**Proposed EV Mobility City with Ancillary Staff Quarters and
Talent Accommodation at Various Lots in D.D. 51 and
Adjoining Government Land, Fanling
(Application No. Y/FSS/20)
- Further Information No. 3 -**

**S.12A Amendment of Plan Application
Proposed EV Mobility City with Ancillary Staff Quarters
and Talent Accommodation at Various Lots in D.D. 51 and
Adjoining Government Land, Fanling**

(Application No. Y/FSS/20)

Comments	Responses
Comments from Environmental Protection Department (Contact Person: Ms. Trista LAU; Tel: 2835 1152)	
1. the applicant shall confirm noise generating activities would be located away as far as possible from any noise sensitive receivers (esp. the nearby Fanling Area 48 public housing sites) and within the enclosed building. Also, pls. confirm whether noisy operations during sensitive hours (e.g., 11pm to 7am) will be prohibited;	The Proposed Development, which mainly focuses on clean energy and EV, as well as R&D works, is non-polluting in nature. Unlike conventional factory (e.g. car manufacturing), noise impact on the surroundings during operational stage is not expected. Noise generating activities, if any, would be located within the enclosed b

Appendix: 1.1	
Title: Site Survey Record Plan	
Project: Proposed EV Mobility City with Ancillary Staff Quarters and Talent Accommodation at Various Lots in D.D. 51 and Adjoining Government Land, Fanling	Drawn by: GW
	Checked by: BF
	Rev.: 1.0
	Date: Jul 2025

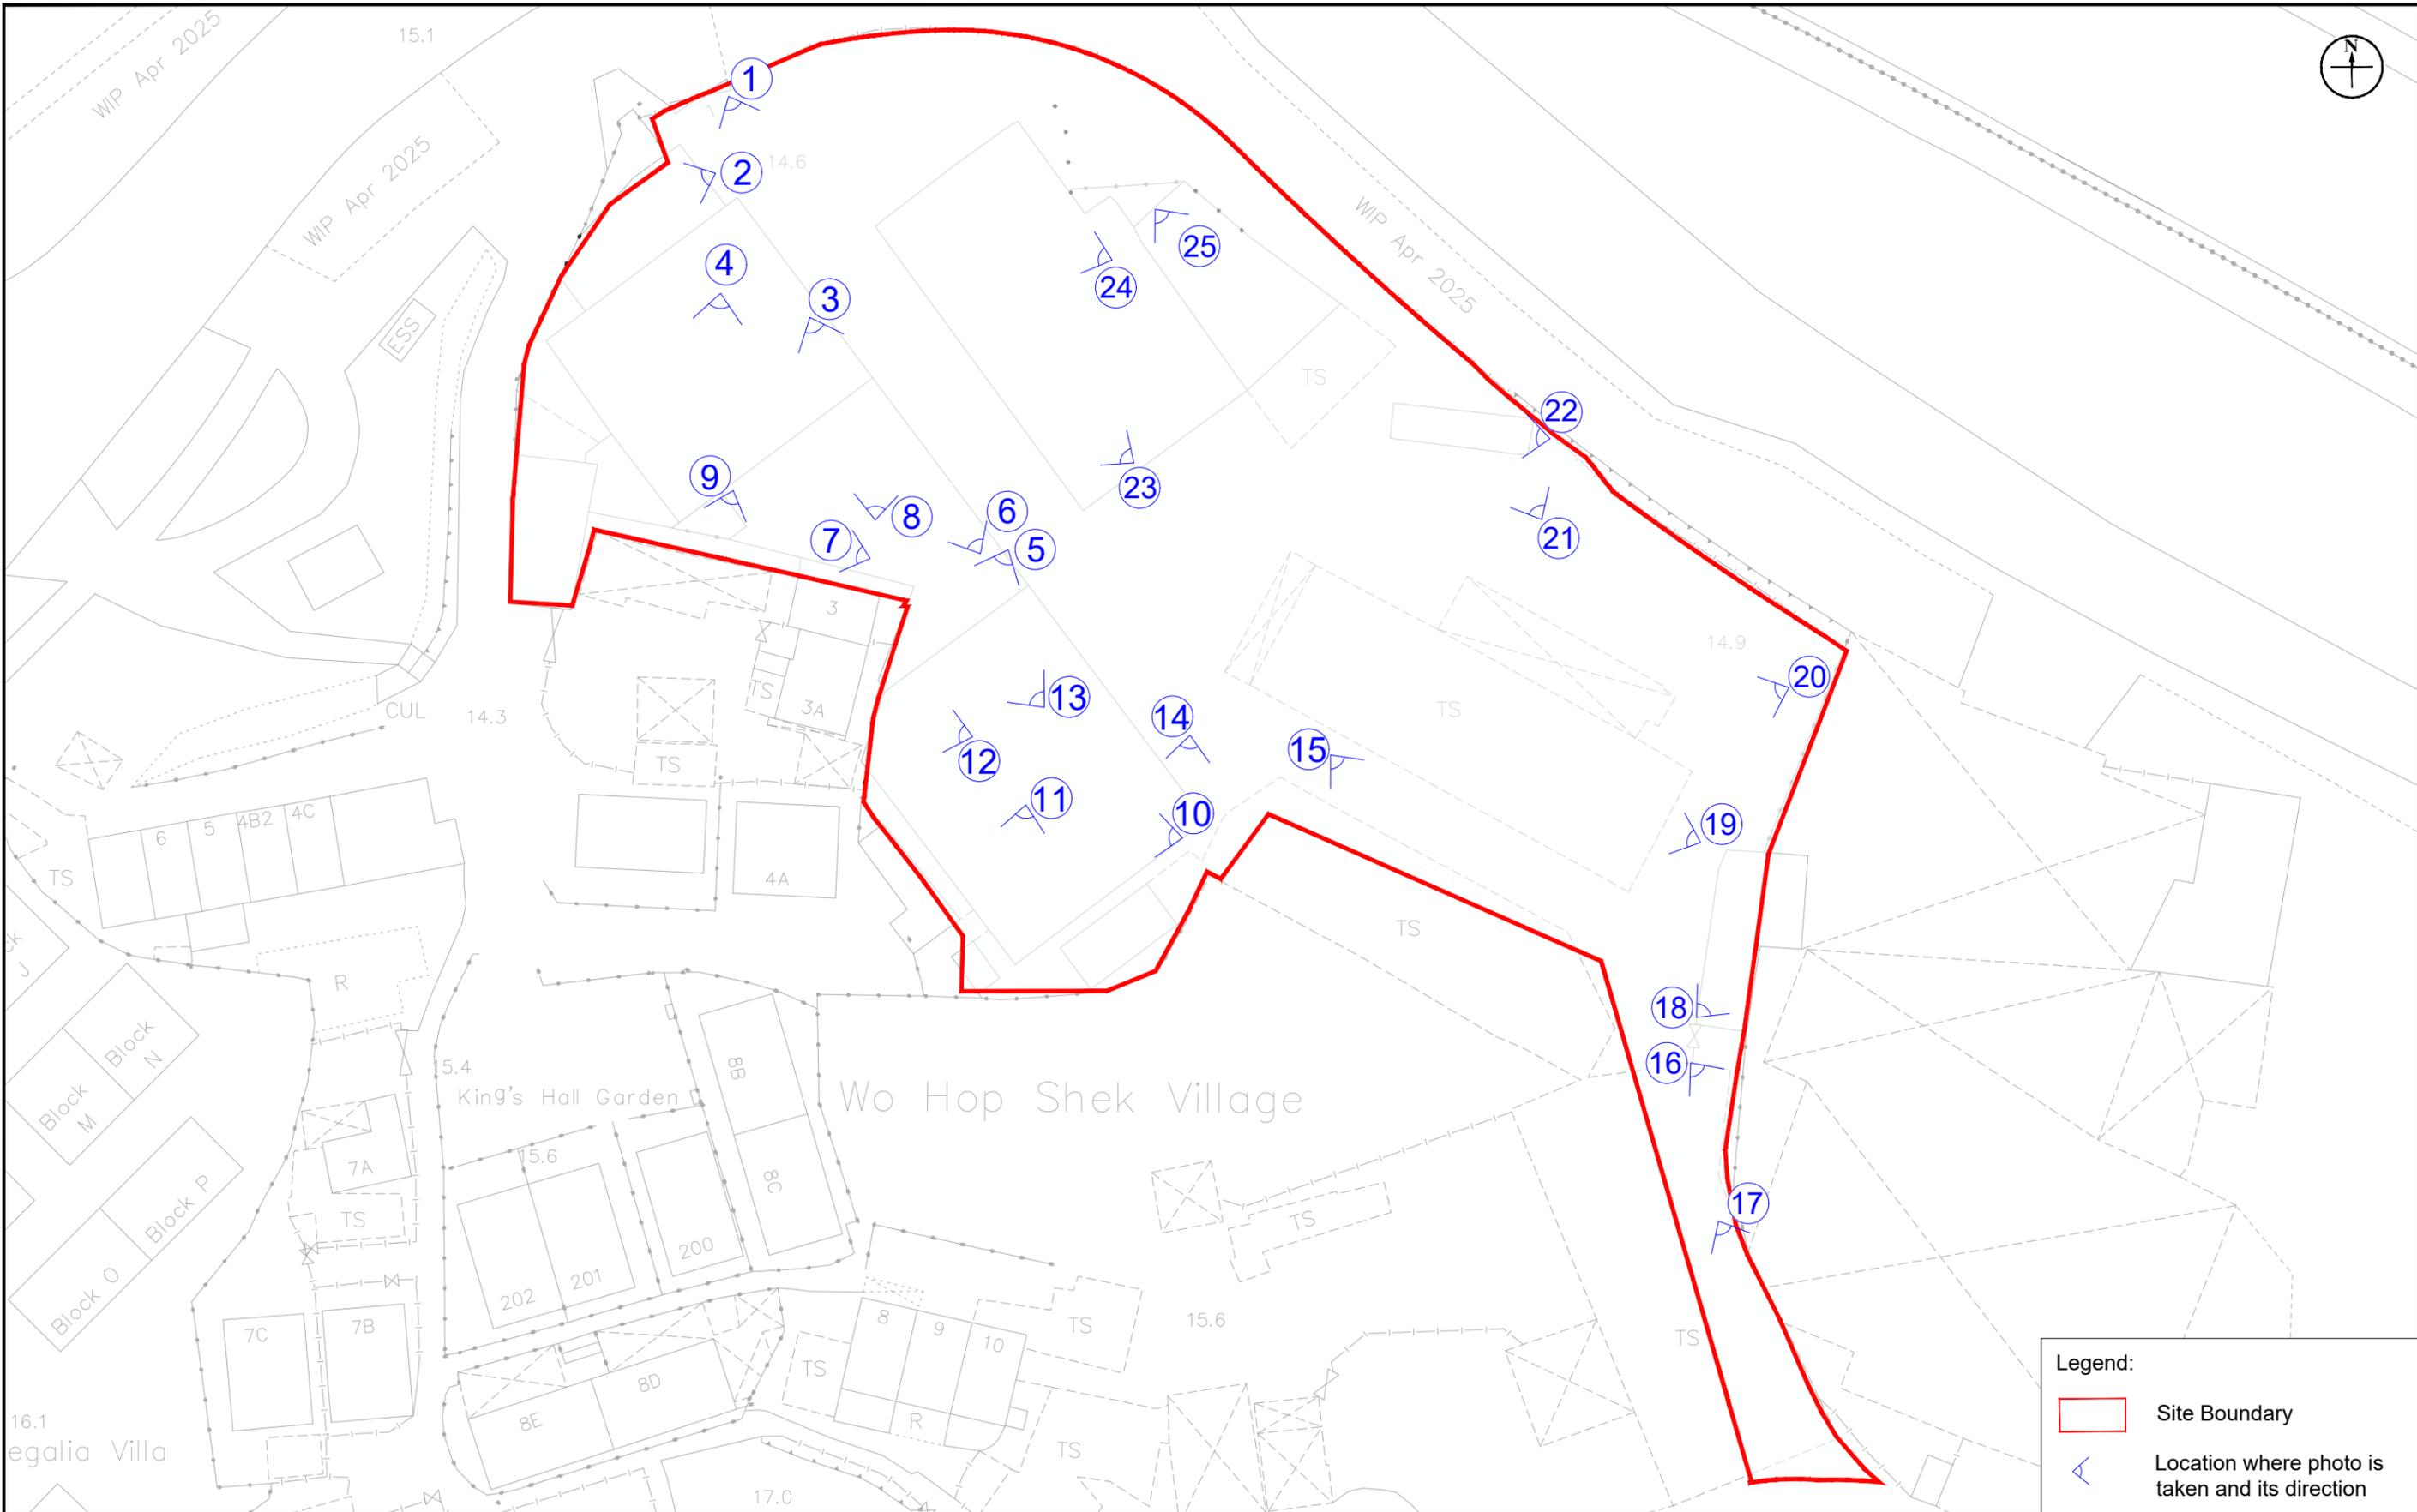
Comments	Responses
<p>the adjacent catchment areas or adversely affect the existing drainage system.</p>	
<p>3. Appendix 3.4 and Section 2.1.3:</p> <ul style="list-style-type: none"> • Please indicate the concerned "uphill catchment" and associated slope drains in Appendix 3.4. • Please provide more detailed description of the proposed internal drains within the site (e.g. alignment, dimension, catchment delineation, capacity check, discharge points, etc. • Please include site photos of the existing drainage system within the site for our reference. 	<ul style="list-style-type: none"> • The uphill catchment and associated slope drains have been indicated in Appendix 3.4. • A peripheral drainage channel has been proposed within the Application Site. The proposed alignment is presented in Figure 2.1, and the corresponding hydraulic calculations have been updated and provided in Appendix 2.1. • According to the site survey, there is no drainage system observed within the Application Site. Please refer to the newly added Appendix 1.1.

Appendix 1.1 Site Visit Photo Record
